**UNIVERSITY OF NORTH CAROLINA AT CHARLOTTE  
CAMPUS INFRASTRUCTURE DEVELOPMENT (CID)  
PHASE II - CAMPUS WI-FI  
BUILDINGS: CAMERON, COLVARD NORTH,  
FRETWELL, FRIDAY, KING, & SMITH**

CN NO: 5462  
DATE: 3/31/2015  
DESIGN: PB  
DRAWN: PB  
REVIEW: PP  
REVISIONS  
No. Date Description By  
1 2015-04-23 BID ADDENDUM #2

SHEET TITLE:  
**ADDENDUM #2 - FRETWELL  
 CEILING DEMOLITION PLAN CLARIFICATION  
 SHEET AE202 & AE203**

DWG. NO.  
**BD-02**

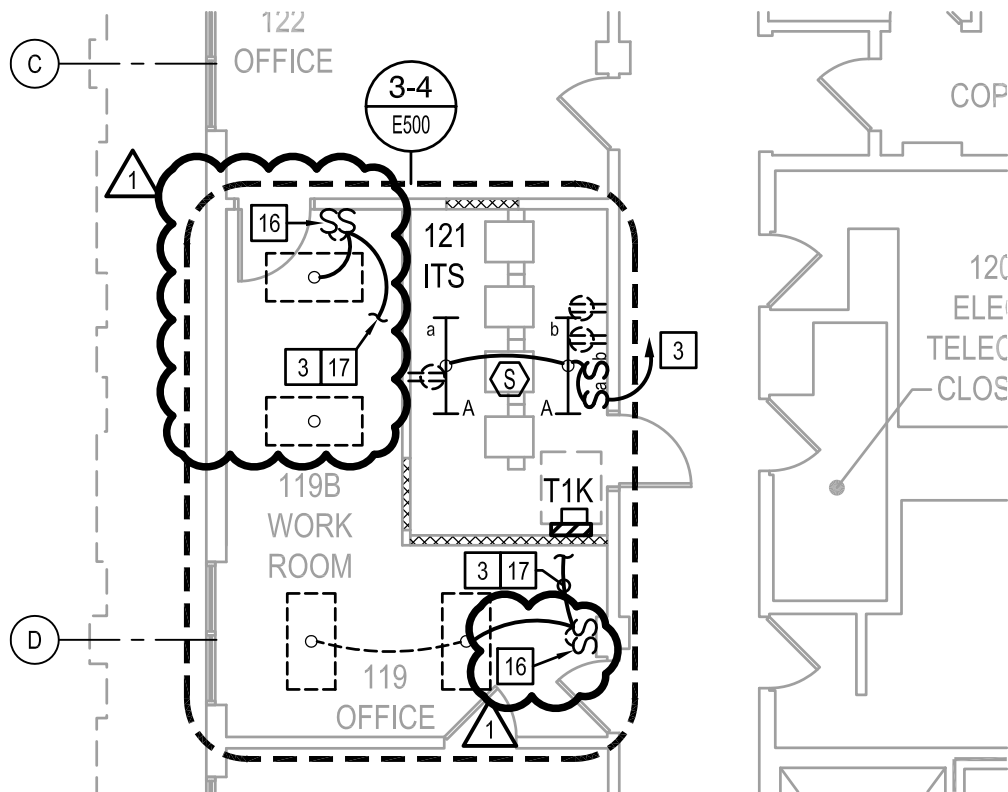
SHEET TITLE:  
**ADDENDUM #2 - KING  
 WORKROOM | 119B REVISIONS  
 SHEET E500**

DWG. NO.  
**BD-03**

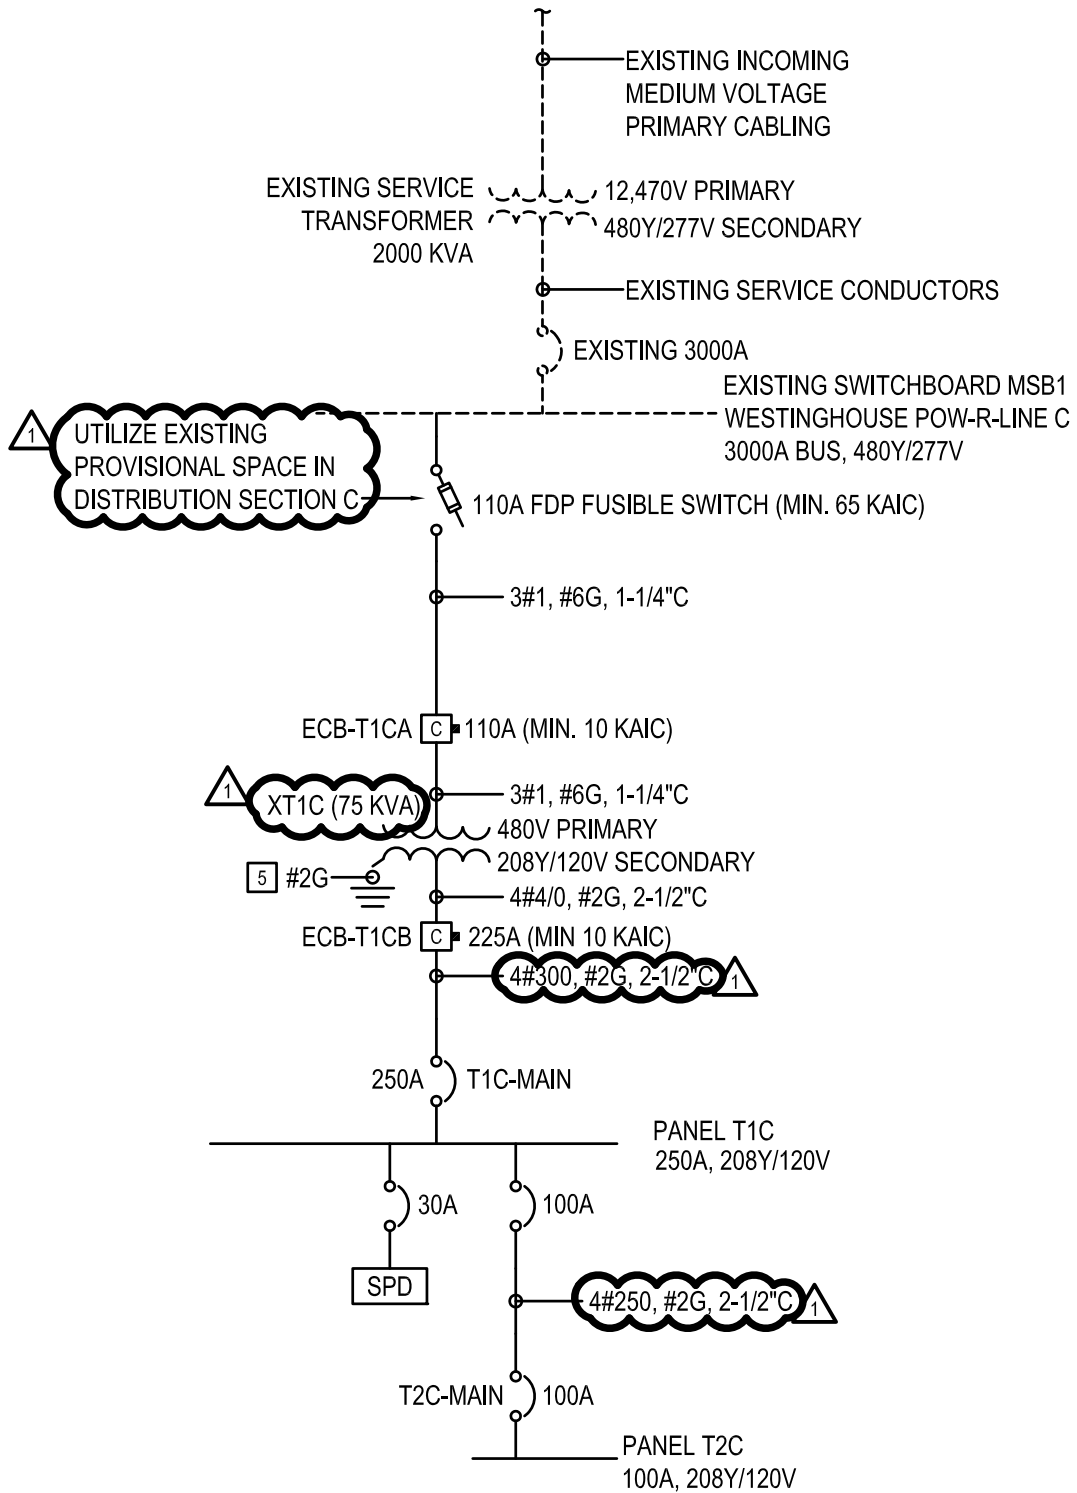
SHEET TITLE:  
**ADDENDUM #2 - KING  
 WORKROOM 119B REVISIONS  
 SHEET E500**

DWG. NO.  
**BD-04**

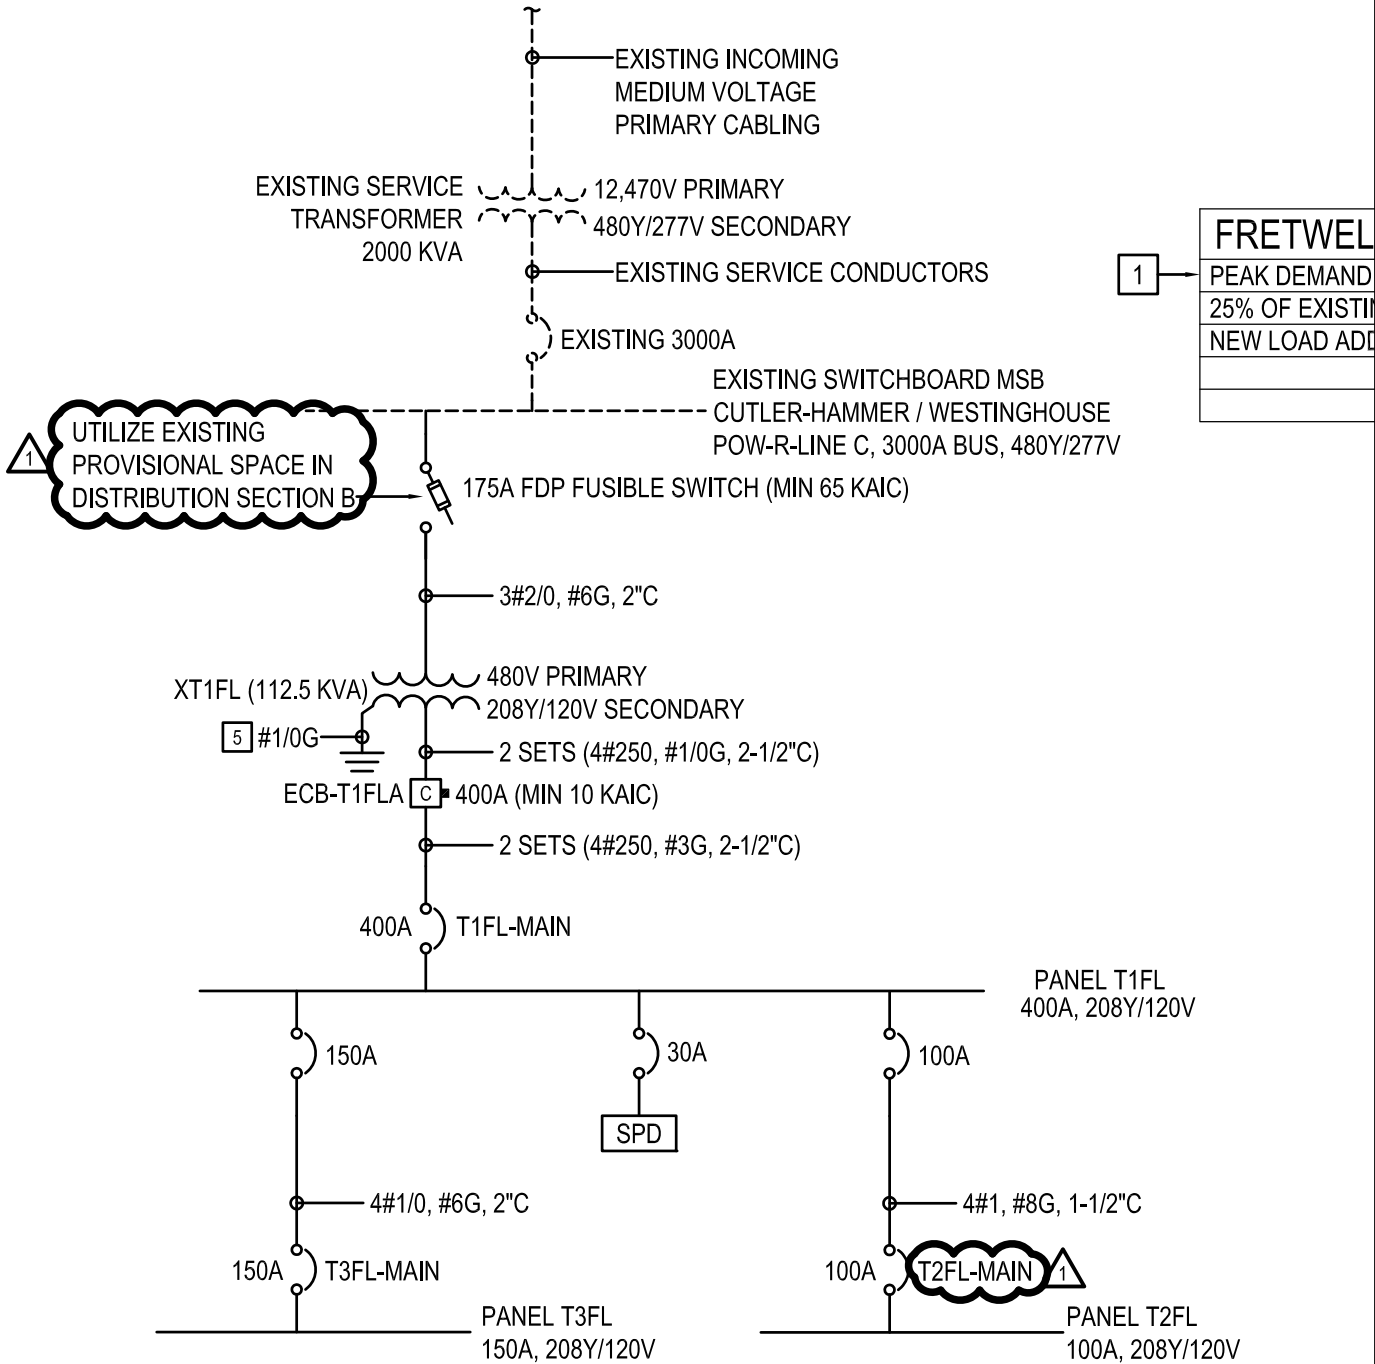
SHEET TITLE:  
**ADDENDUM #2 - CAMERON  
 SINGLE-LINE REVISIONS  
 SHEET E701**

DWG. NO.  
**BD-05**

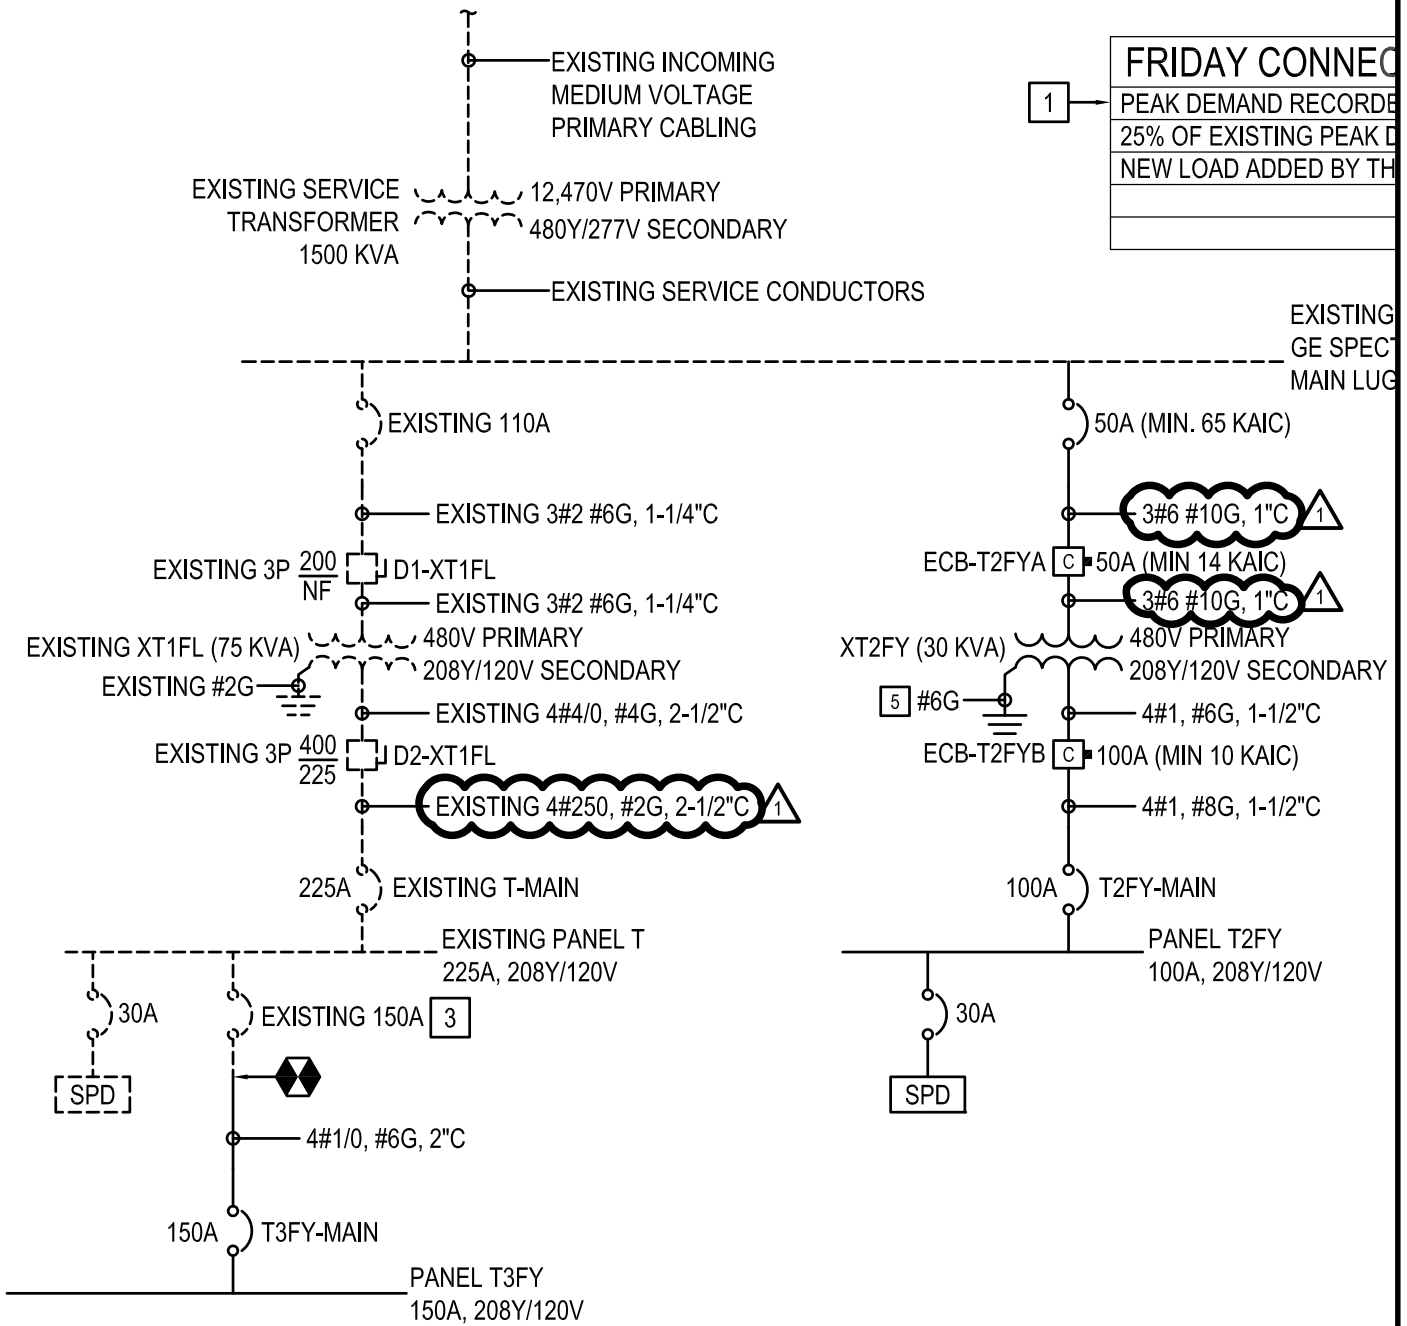
SHEET TITLE:  
**ADDENDUM #2 - FRETWELL  
 SINGLE-LINE REVISIONS  
 SHEET E701**

DWG. NO.  
**BD-06**

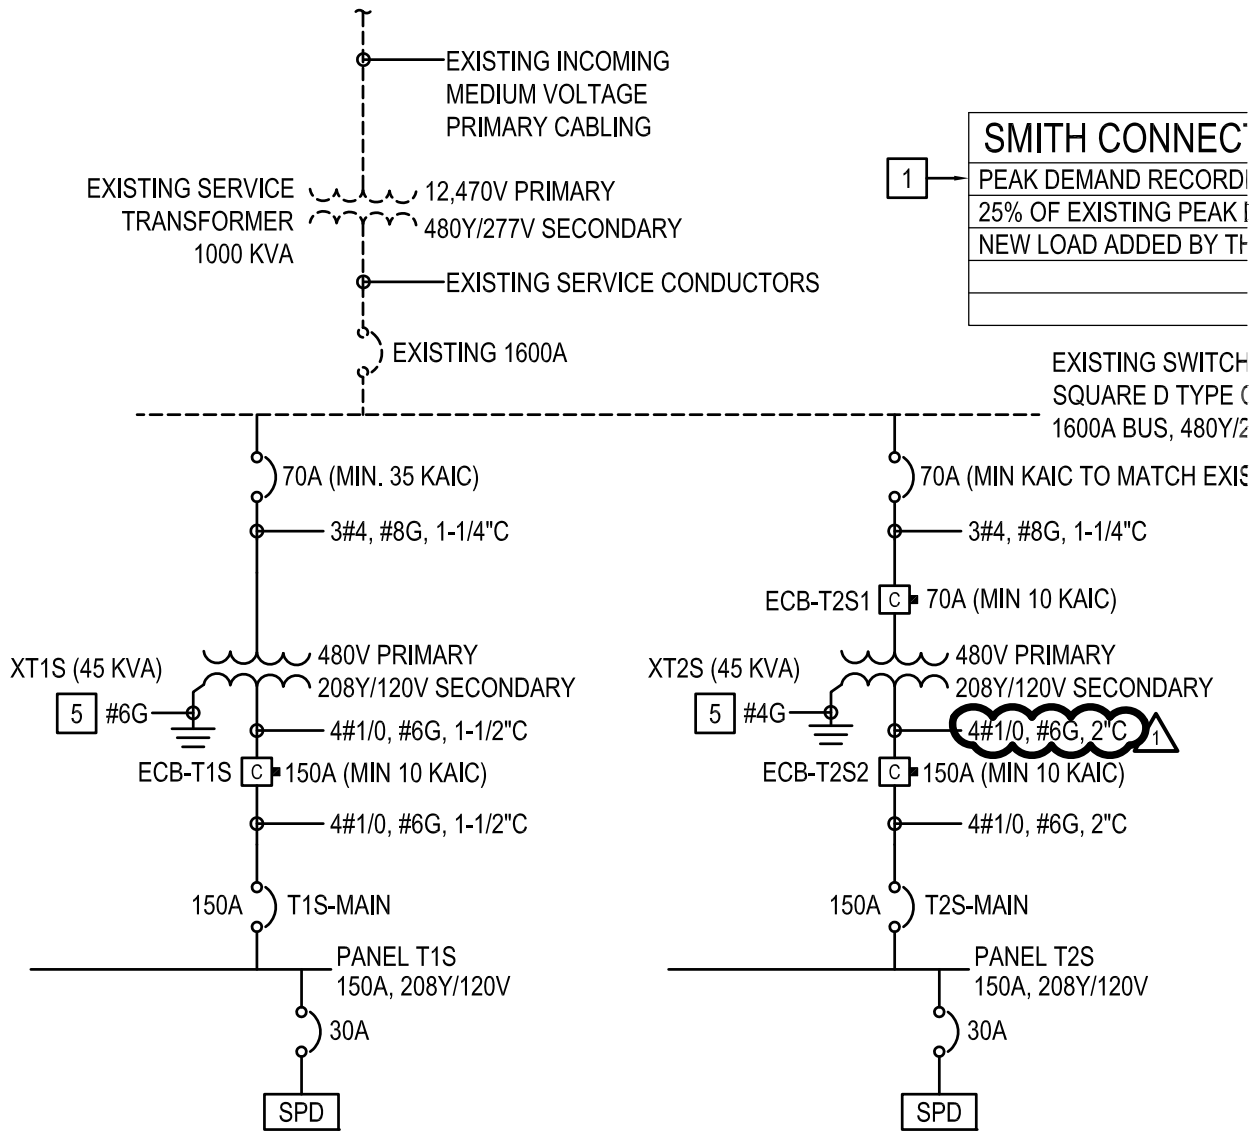
SHEET TITLE:  
**ADDENDUM #2 - FRIDAY  
 SINGLE-LINE REVISIONS  
 SHEET E70I**
